EAGLE MOUNTAIN PLANNING COMMISSION MEETING

January 8th 2019 6:00 p.m.

EAGLE MOUNTAIN CITY
Planning Commission Staff Report
JANUARY 8, 2019

Project: Arctic Circle
Applicant: Joey Totorica
Request: Site Plan
Type of Action: Recommendation to City Council

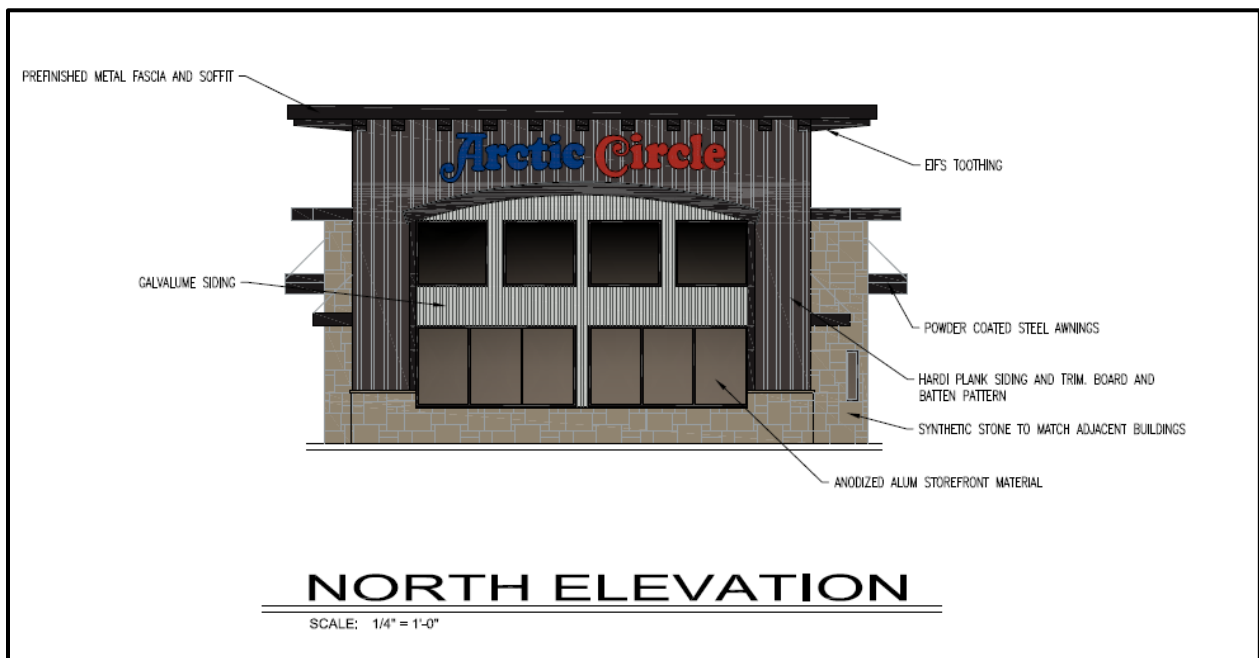
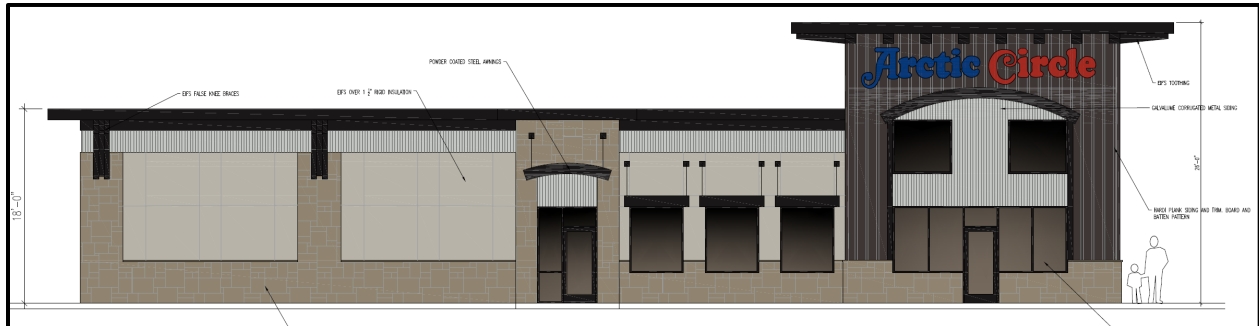
The building square footage is approximately 3,545 sq. ft. Building elevations and renderings have been submitted for the Arctic Circle and are included in the packet. The building design complies with nearly all of the City's Commercial Design Standards. The proposal does use different and acceptable materials. The proposed building is in line and consistent with the currently constructed buildings in this development. EMMC 17.72.040–F2 states:

2. All commercial buildings shall avoid large panelized products or featureless surfaces. Commercial buildings shall utilize an appropriate mixture of building materials on all sides, including brick, rock, fiber/cement siding, wood, glass, stucco, and colored architectural CMU (concrete masonry unit). Stucco may not be used on more than 50 percent of a building. Metal, plain CMU, or other materials deemed appropriate by the planning commission and city council may be used as accents only.

G. Building Color. Buildings should not be restricted to using desert landscape colors, such as beige, tan, grays, browns, etc. A wide palette of colors is recommended, excluding any neon, ultra-bright, or reflective colors. A building's color palette should be similar to that of significant neighboring structures. Franchise colors and elements may be incorporated, but shall not overpower the architectural form/theme of the building and/or development.

It is up to the Planning Commission and the City Council to determine if the materials and brand colors of the Arctic Circle are similar to the neighboring structures in the development.

Figure 1 Current Trail Plan (Right)

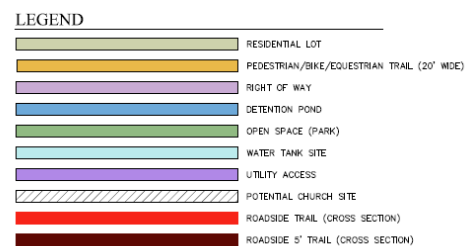
Trail: The applicant is proposing to alter the trail plan, with the main change removing trails from the back side of lots and instead placing them along the roads. It also moves the location of cross block connectors in a way the applicant feels makes more sense. The plan also removes the equestrian trail along the wash.

17.25.110 G states "Equestrian trails that adjoin each lot shall be required improvements when the subdivision is designed to accommodate horse raising and keeping" The Planning Commission should indicate whether they feel this proposal complies (and/or) is subject to this provision

Figure 2 Elevations

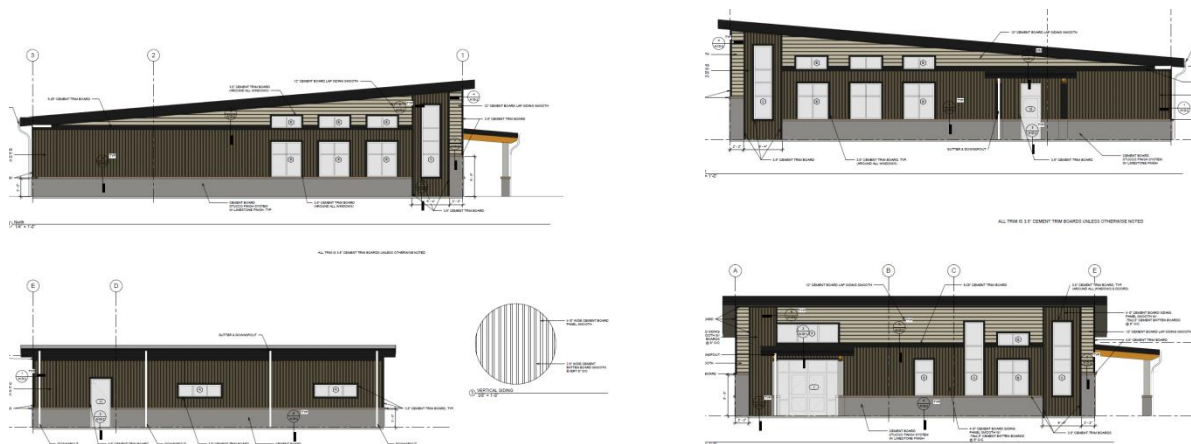
While the proposed clubhouse largely meets the Commercial and Multifamily design standards the Planning Commission should make a recommendation regarding the proposed Colors and building articulation EMMC 17.72.040 D states:

"...Buildings shall include façade modulation (stepping portions of the façade), horizontal and vertical divisions (Textures or Materials), window patterns, offsets, recesses, projections, varied front setbacks or staggered and jogged unit planes within the same structure, and other techniques...to avoid large, featureless and/or panelized surfaces."

The proposed elevations use textures, materials, and patterns to create varied visuals. The applicant has provided two awnings, but the building facades remains largely flat with little physical articulation, staff recommends additional articulation particularly on the west (main) façade, the Planning Commission should consider the elevations and make a recommendation to the council on the articulation that is provided.

Thus it is the opinion of staff that additional colors should be used, including colors that match the color scheme of the townhomes within the project.

1. *Additional physical articulation added to clubhouse elevations, particularly the West Façade (if you deem appropriate)*
2. *Additional colors should be used for the clubhouse, including colors that match the townhomes in the development.*
3. *Any additional condition(s) the Planning Commission feels are appropriate*

Figure 2 Potential Western Connection

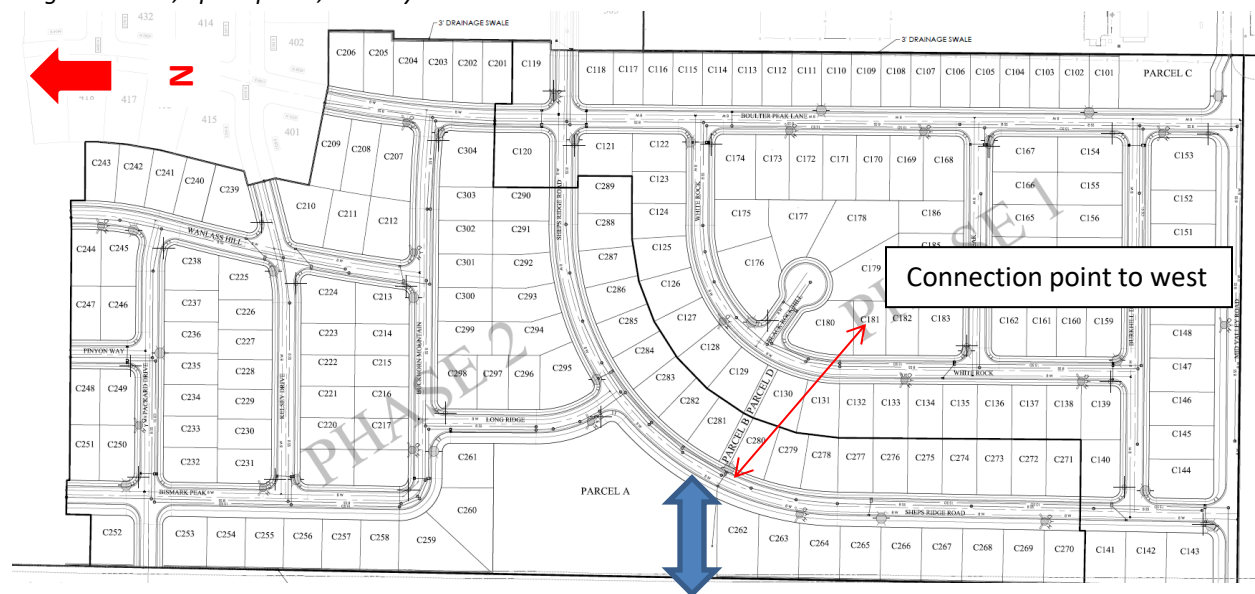
EMMC **16.30.090.C.4** advocates for external connectivity among projects, calling for a minimum of a paved eight foot pedestrian access to future planned subdivisions. The property owner to the west of the project has approached the City and indicated their desire to master plan a development on their 160 acre parcel, and they have requested an additional east-west connection into Overland. For connectivity purposes staff feels like an additional connection would be a benefit, and sees an ideal location on the south of the proposed park. A connection here would also support the General Plan **Objective 4 in Chapter 6: "Enhance connectivity between neighborhoods, open spaces, and city destinations."**

1. *Applicant shall provide a Detailed Park Plan to be approved by the City Council*
2. *An additional road stub shall be provided to the west of the project, on the south side of the park*
3. *Two egress lanes are provided on Sheps Ridge Road accessing onto Pony Express Parkway*
4. *Any other conditions the Planning Commission Deems Appropriate*

Figure 3 Roads with 63' ROW

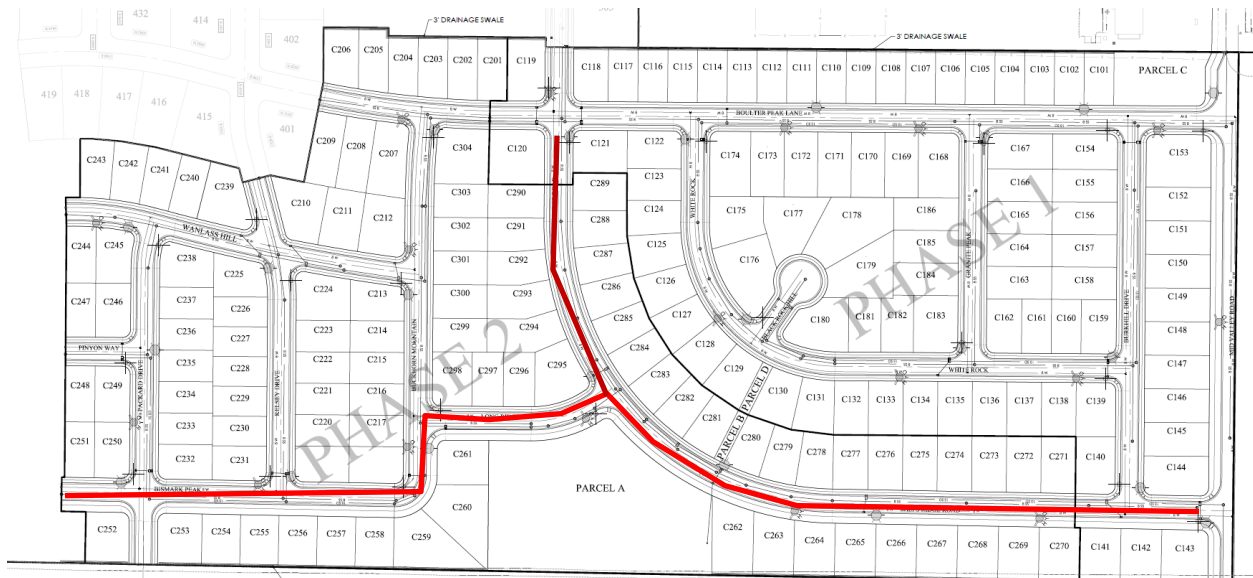
ROW Widths: The applicant has provided a ROW width table within their submittal. While they have corrected most of the problems from the last submittal the table still shows Boulder Peak Lane with a 77 foot ROW, when in actuality it is a standard 53 foot local road.

The new plat does show Sheps Ridge Road as 63' until it meets with Boulter Peak Lane. Long Ridge is shown with a 63 foot right-of-way, and Bismark Peak is shown with a 63 foot right-of-way as requested by the Planning Commission and staff.

Figure 5 Village 1 Concept Plan (Above) Color Coded (Below)

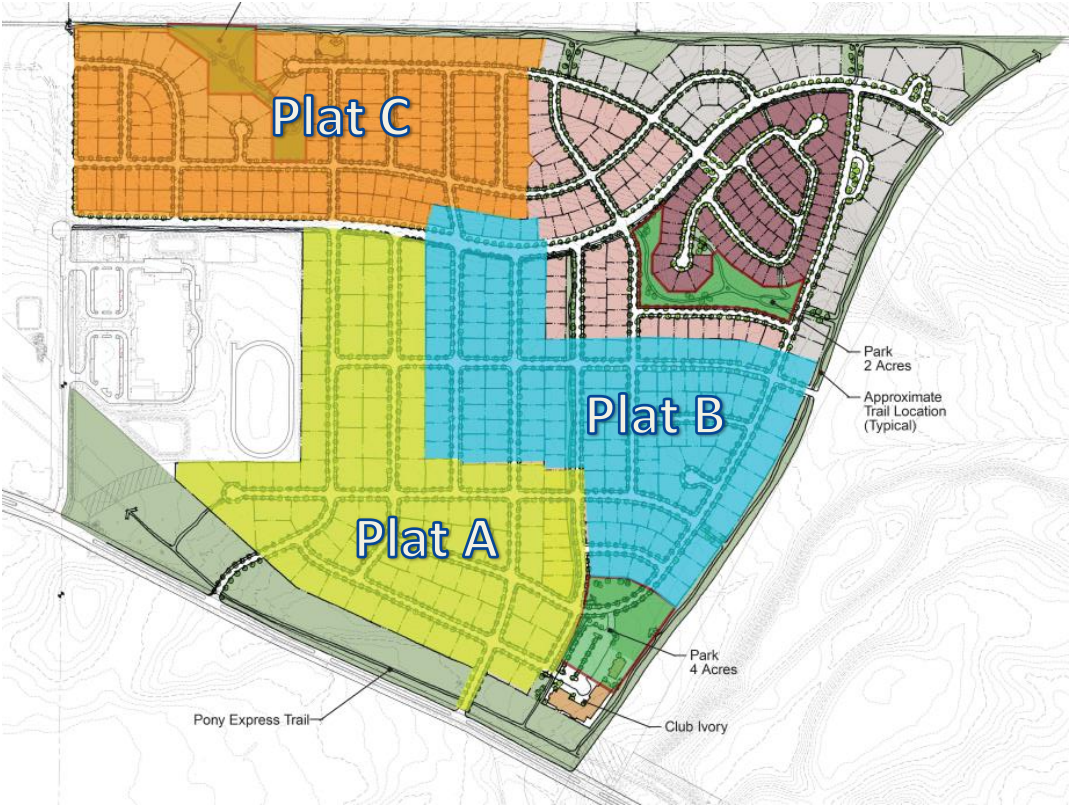
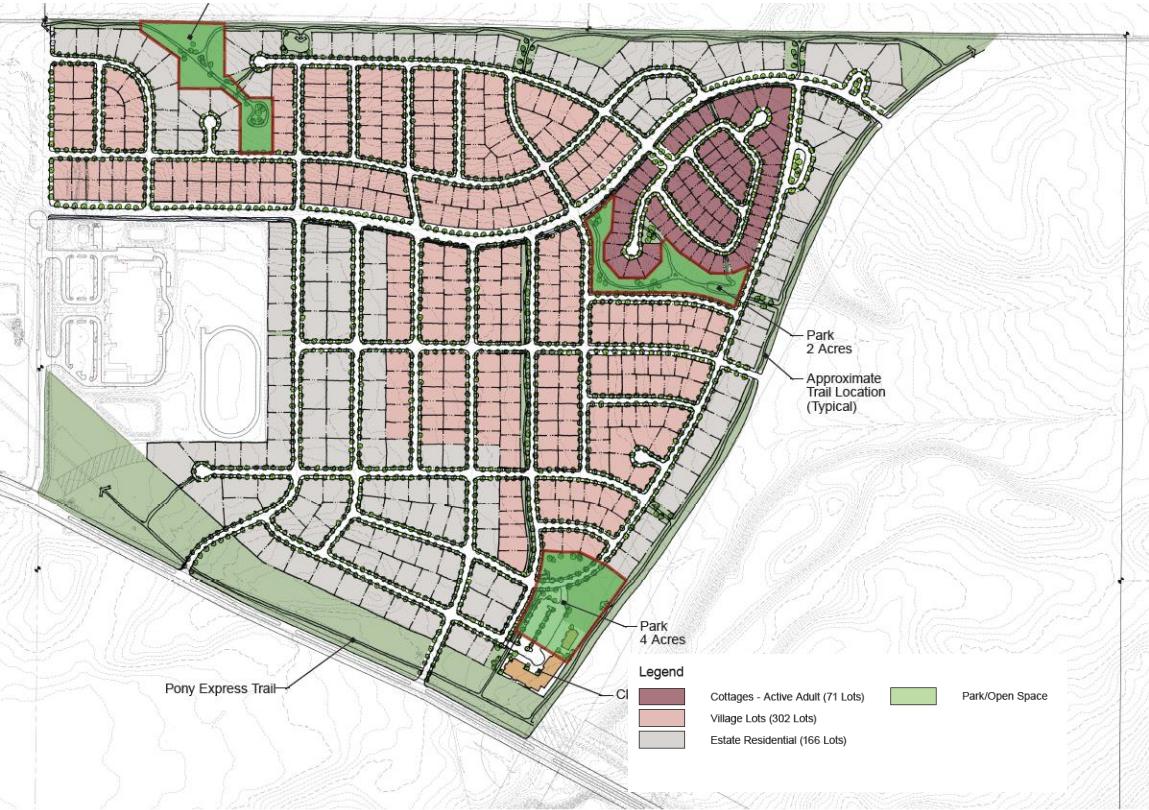
Village Concept Plan: The conceptual village plan for Overland Village 1 is significantly different than the preliminary plat that was received. While the village plan was for conceptual purposes only, staff feels that since the larger "estate lots" have been removed the applicant should provide an explanation for why they are not complying with the conceptual plan, as well as an explanation of how/where they will be providing larger "estate lots" elsewhere in the development.

The applicant has indicated that their market research shows people want large backyards and homes, but not necessarily larger lots and that large lots are cost-prohibitive due to landscaping and water costs.
